RESPONSE TO COMMENTS

City of Miami Beach,
Wachovia – Alton Road
Response to Building Dept. Cmts.
Page 2 of 4

WACHOVIA - ALTON ROAD BRANCH
1901 ALTON ROAD
MIAMI BEACH, FLORIDA

DESCRIPTION OF WORK:	Construction of New Exterior ADA Ramp; Relocation of ATM & AHD Equipment; Minor Interior Remodel to Create a New ATM Room.
BUILDING CODES:	FLORIDA BUILDING CODE, 2004 EDITION 2004 FLORIDA FIRE PREVENTION CODE NFPA 101, LIFE SAFETY CODE, 2003 EDITION
BUILDING TYPE:	TYPE IIIB
CLASSIFICATION OF WORK:	ALTERATION - LEVEL 2
OCCUPANCY TYPE:	BUSINESS
OVERALL EXISTING BUILDING SQUARE FOOTAGE:	6,085 SF
OCCUPANT LOAD:	1 PERSON/100 S.F. GROSS (6,085 SF/100 SF = 61 PEOPLE)

1 DEMOLITION PLAN
SCALE: 1/4" = 1'-0"

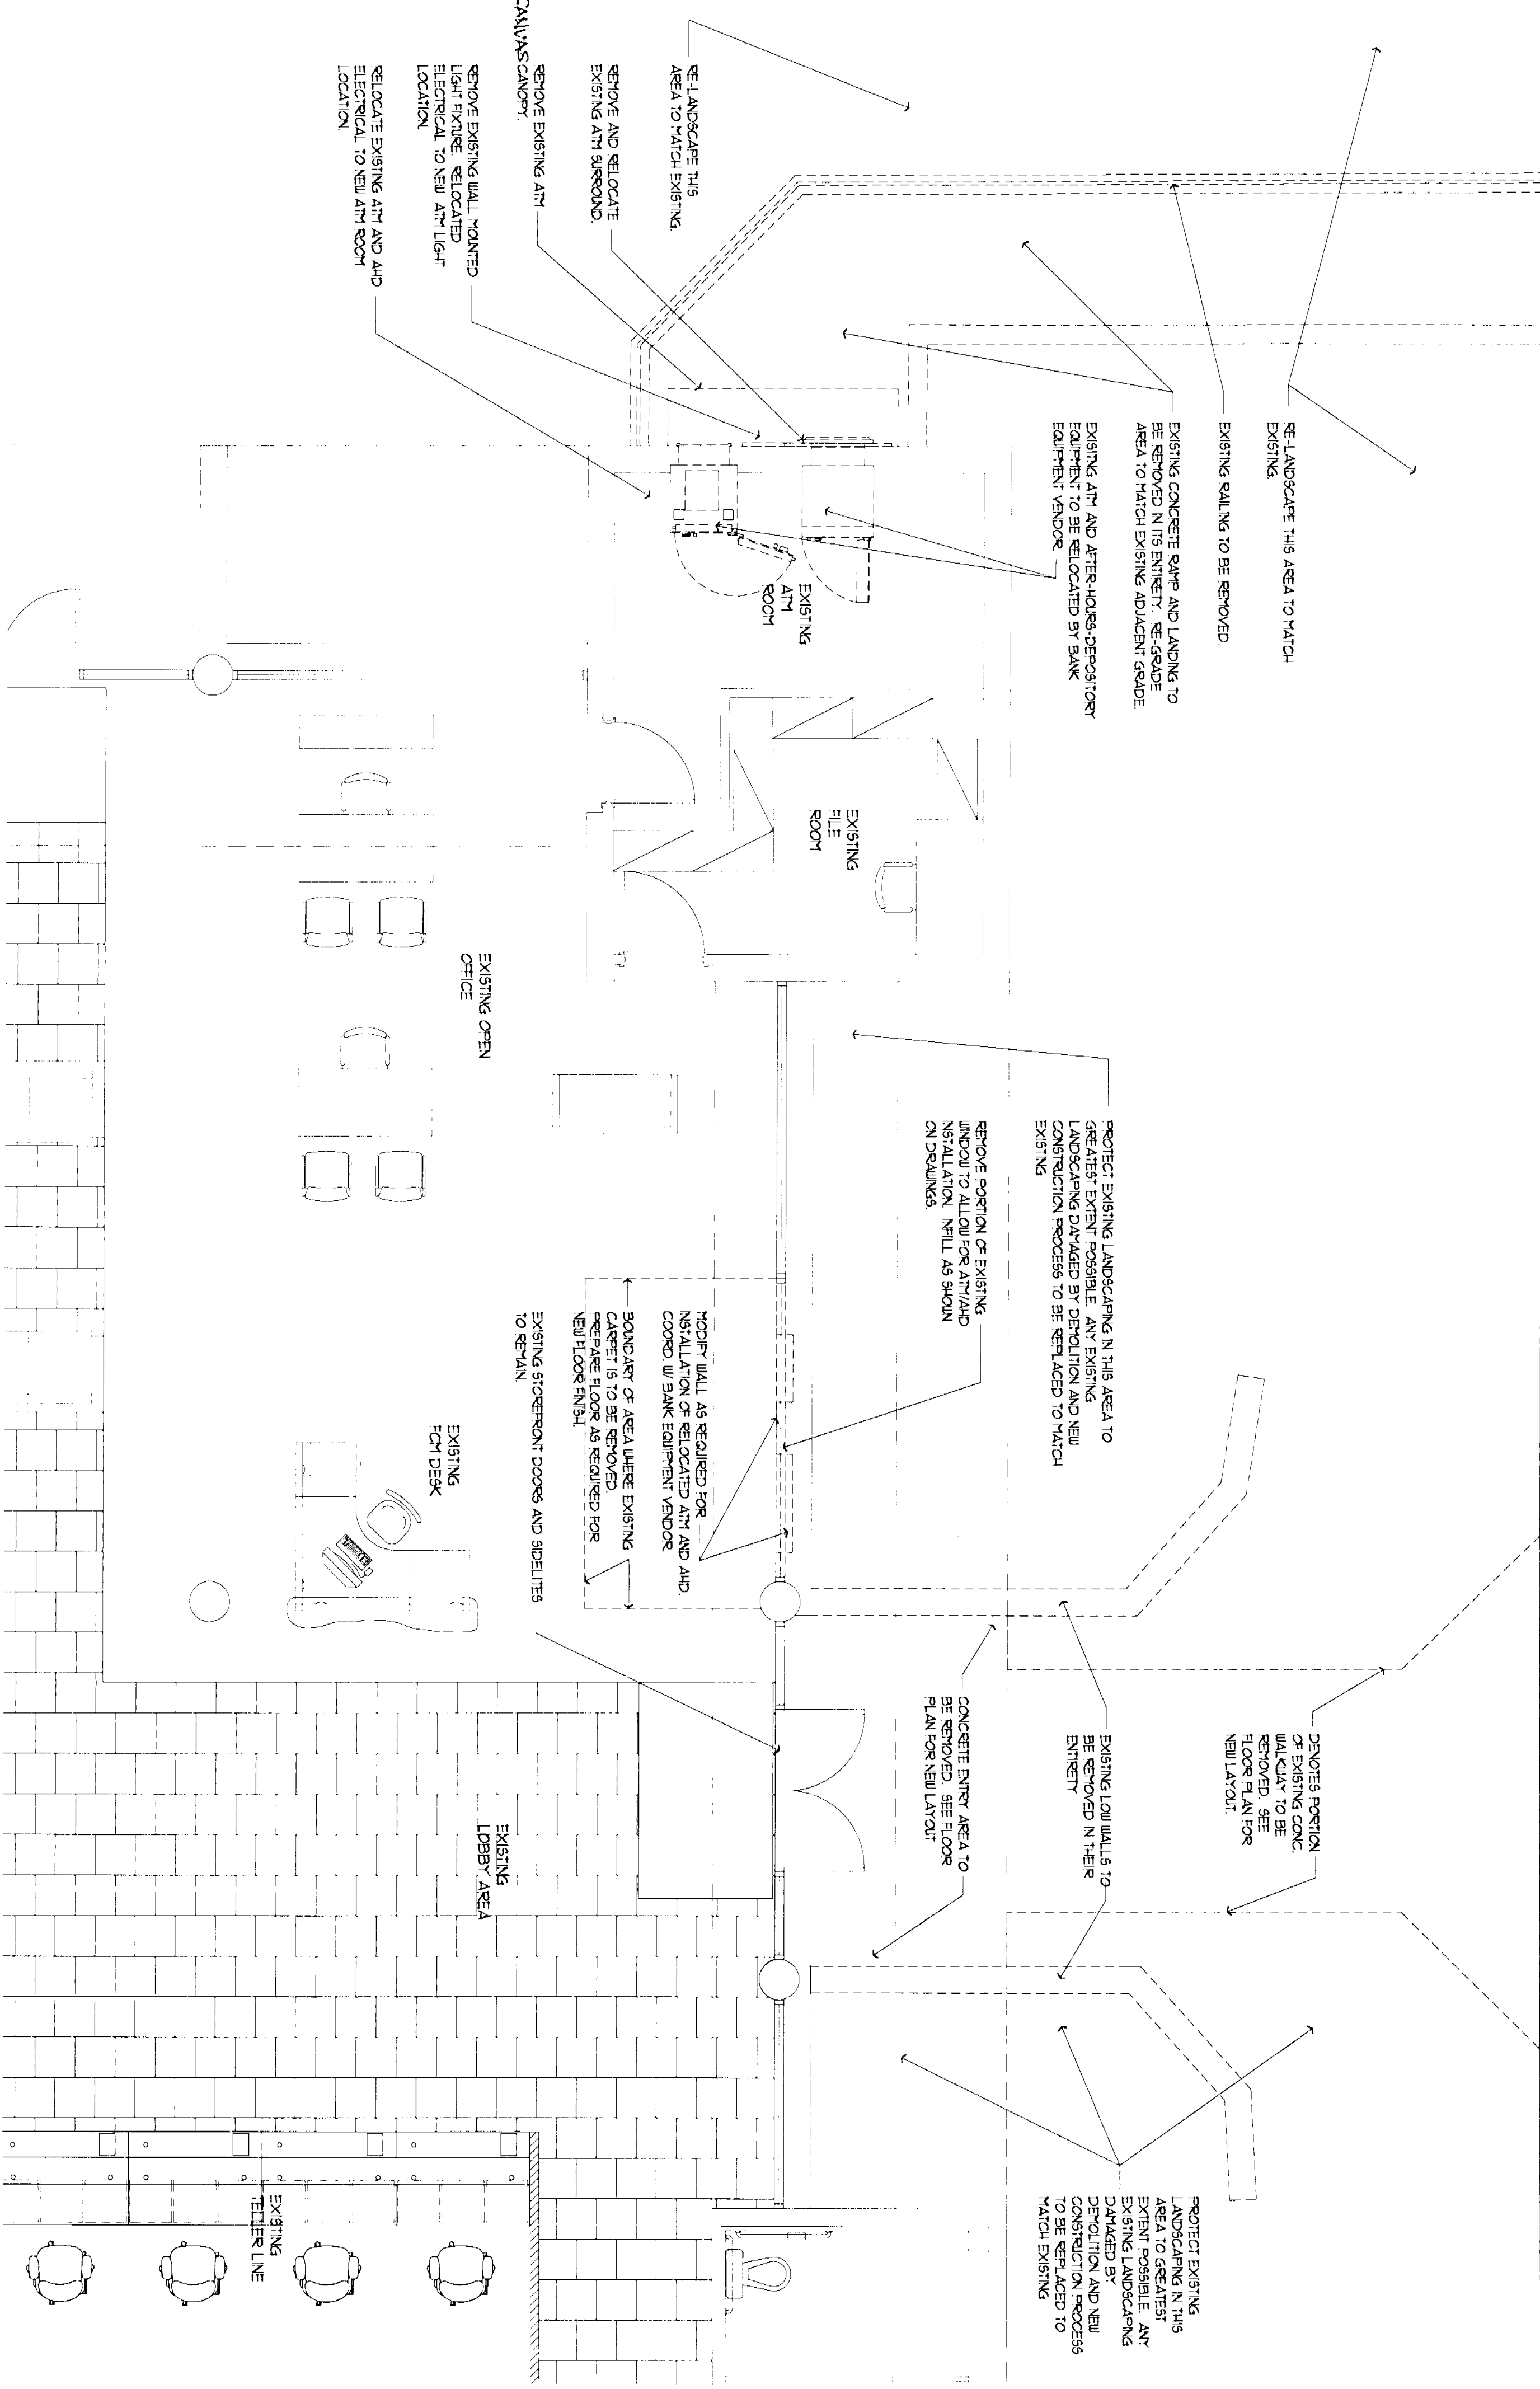
Show and elevation at each surface.

Elevation marks have been placed on the Floor Plan. Refer to revised Sheet A1.0 for the information requested.

1 FLOOR PLAN
SCALE: 1/4" = 1'-0"

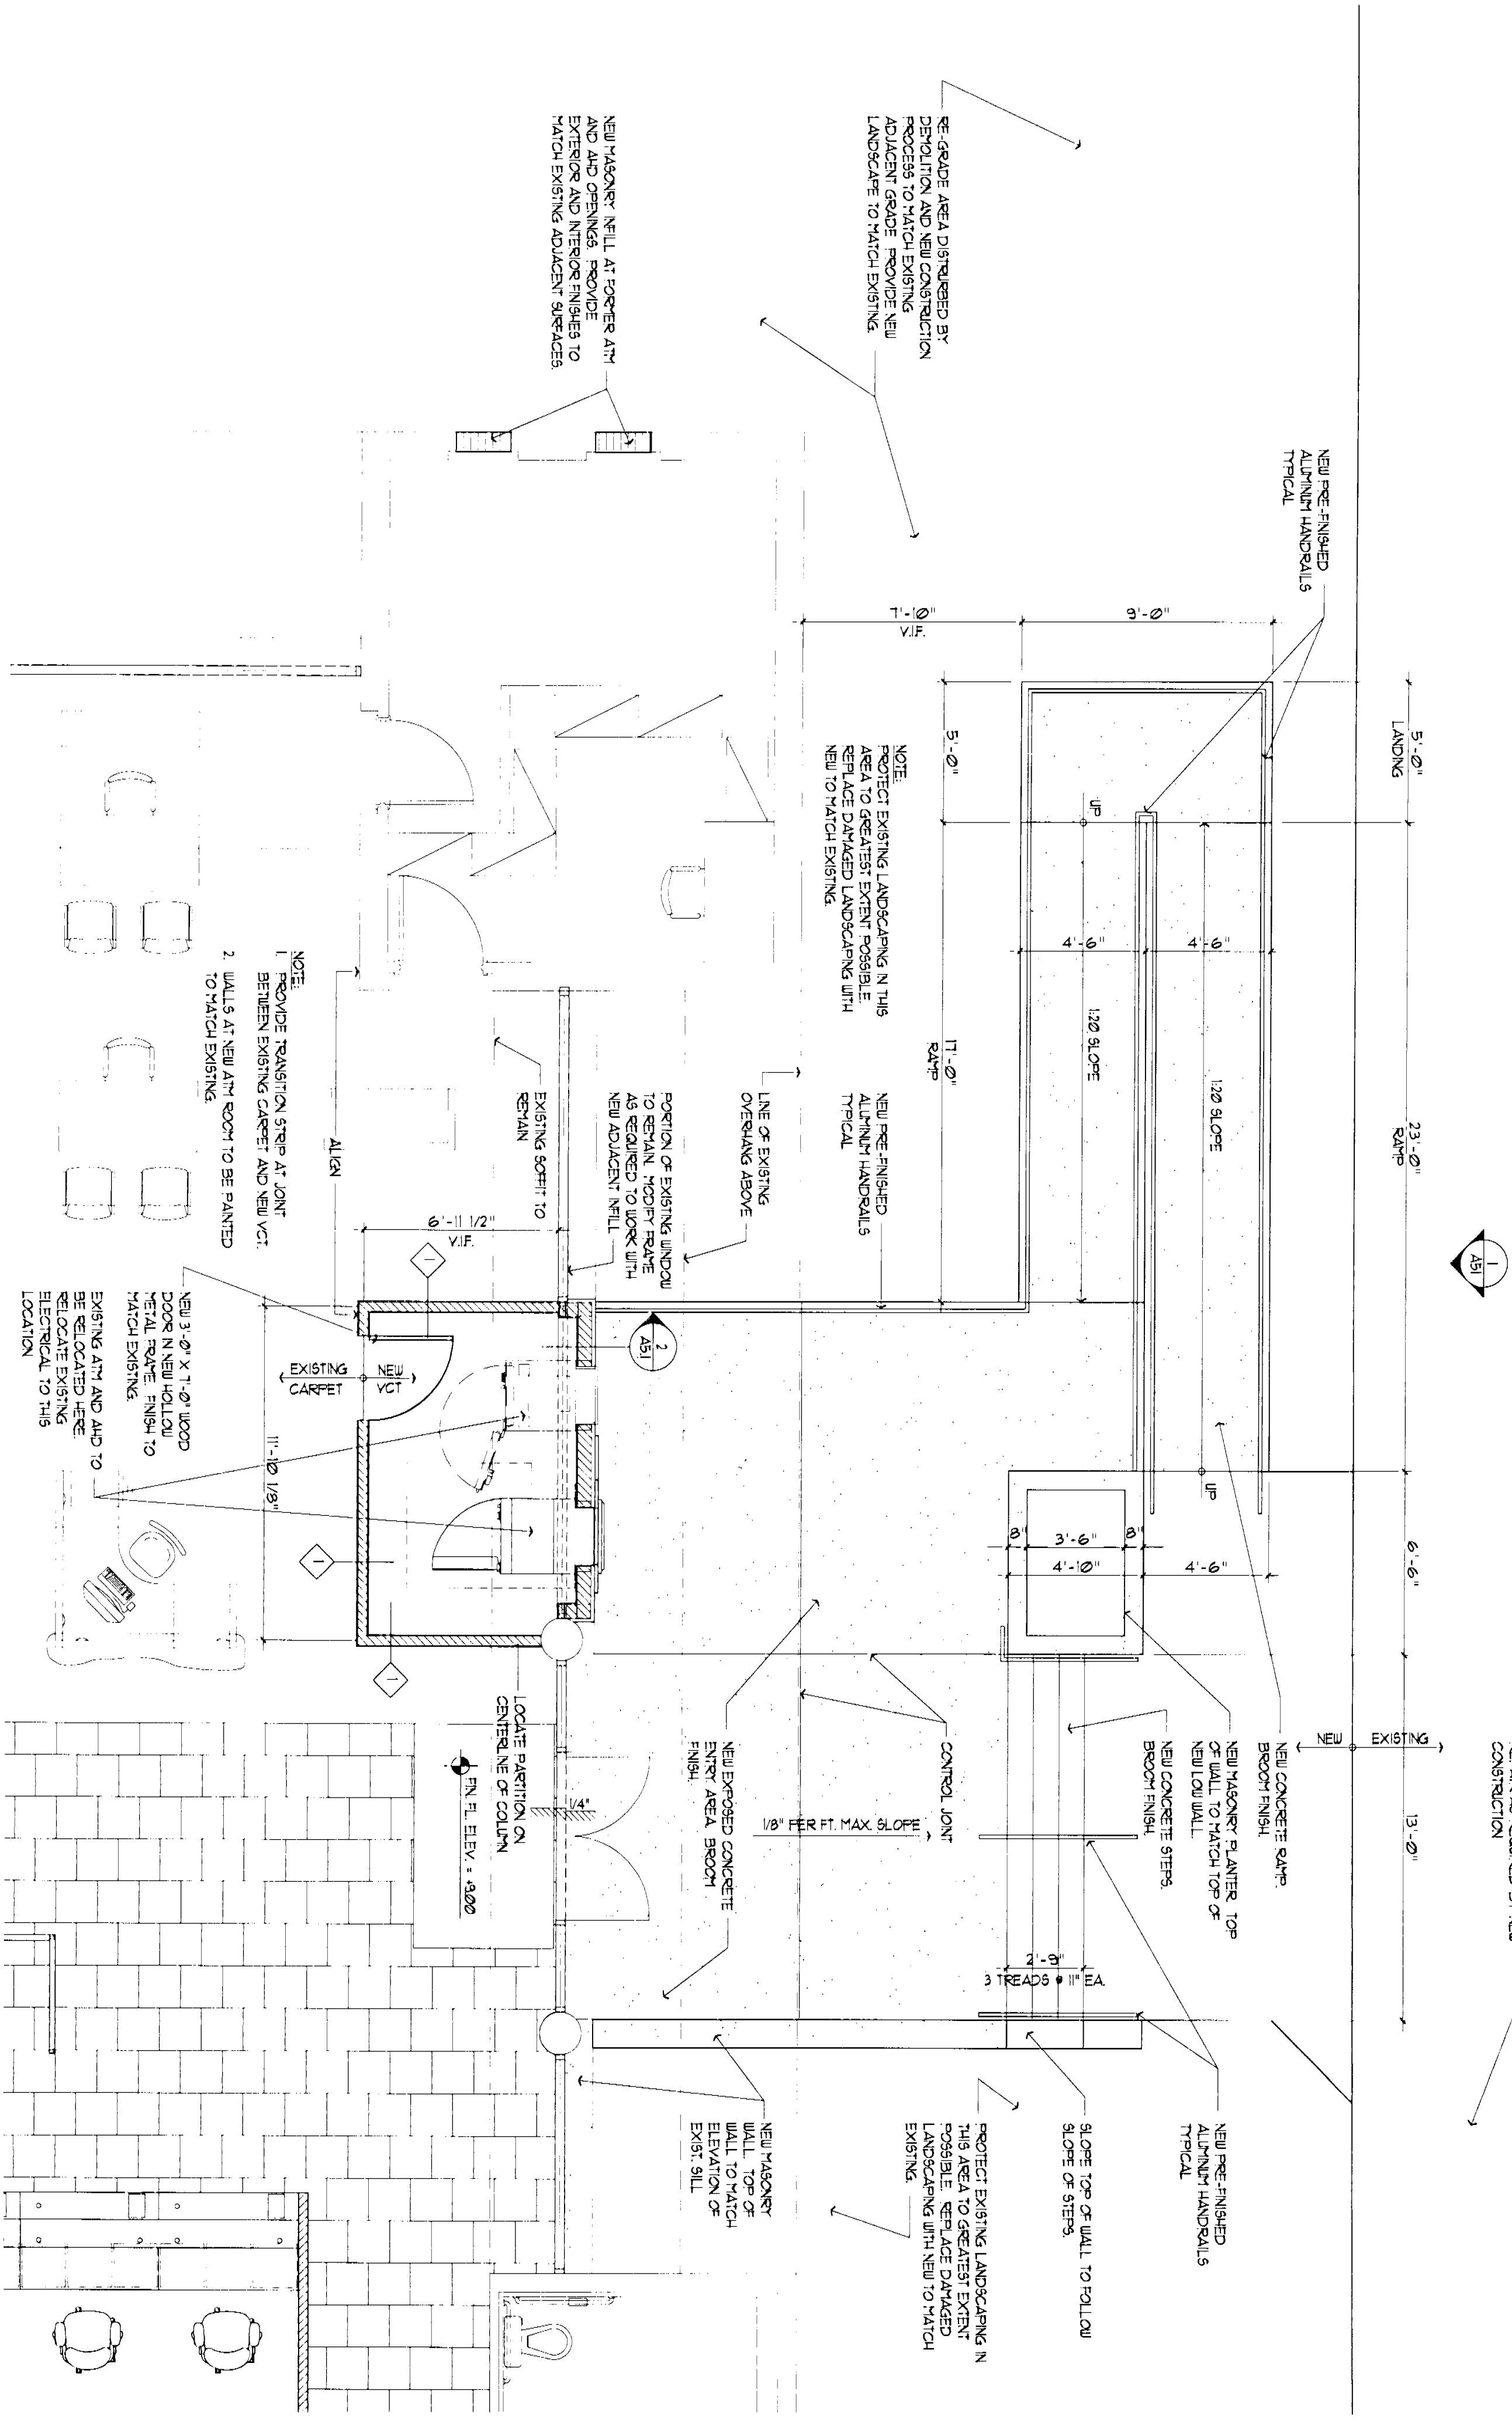
Guards and handrails on both sides shall be provided for ramps. Provide guards and handrail details for ramps.

In accordance with FBC Section 1012.1 and NFPA 7.1.8 guards are required when the open sides exceed 30 inches above the floor or grade below. Please refer to Revised Sheet A1.1 for the applicable grade elevations. The landings and portions of the ramp are, at their maximum, 12" above the grade. Therefore handrails have been provided as opposed to guards.

4 HANDRAIL DETAIL
SCALE: 1-1/2" = 1'-0"

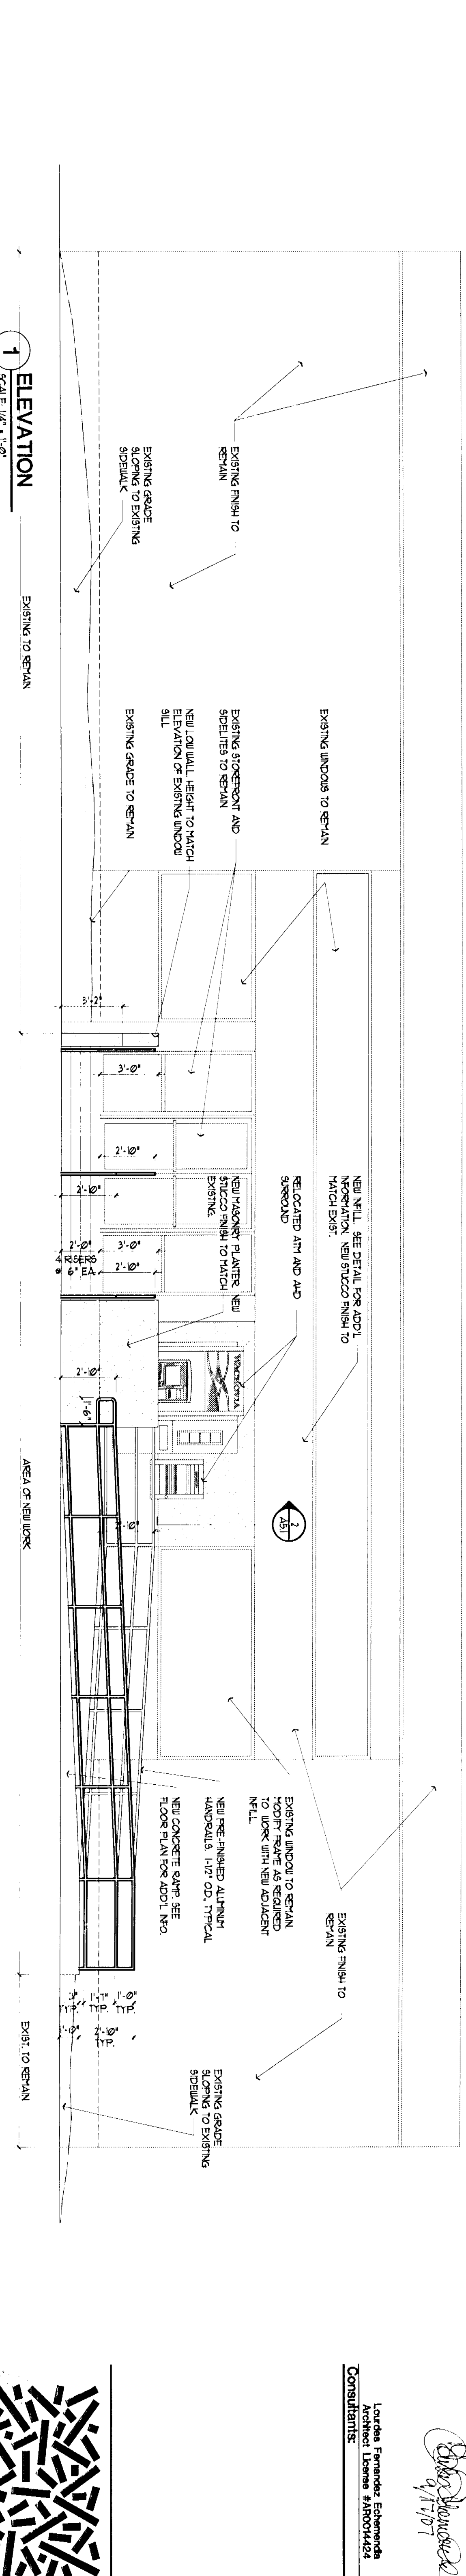
Provide a cross section showing handrail and/or guardrail compliance (FBC 1009.11; FBC 1618) Show a 1-1/2" dimension from top of bracket to bottom of rail.

Refer to new detail 4/A5.1 on Revised Sheet A5.1. This detail as shown satisfies the requirements of both FBC Chapter 11 requirements and those of the FFPC/NFPA 101 Section 7.2.2.4.4.5. Note also that General Note 5 has been added on Sheet A1.1 for compliance w/ FBC 1618.4.6.

Provide handrails with their proper extensions along with 3 steps or less need to be 13" min tread with their nosing striped.

Refer to Revised Sheet A5.1 and new details 3/A5.1 and 5/A5.1. Section 3/A5.1 indicates the required extensions at the handrails. Section 5/A5.1 calls for stair nosings with an anti-slip abrasive texture and color safety yellow. Refer to Revised Sheet A1.1 for the revised tread dimensions. Treads have been modified to be 13".
